REVISIONS			
EV.	DESCRIPTION	DATE	APPROVED
Ą	Draft update and parting line change	7/11/2019	
В	Update to Notes	7/11/2019	
0	Update to draft (wall now 4 deg. for 8 deg. total) in side wall, snap shut off areas	9/6/2019	
D	Part # added in title block	10/30/2019	
E	Drawing Name Update	2/17/2021

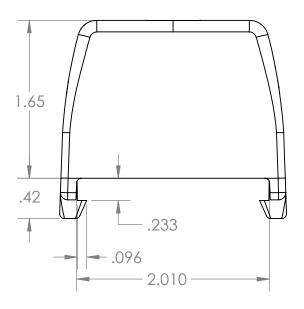
Saddle needs to fit over stock brackets. Will develop a test fixture for in process checks.
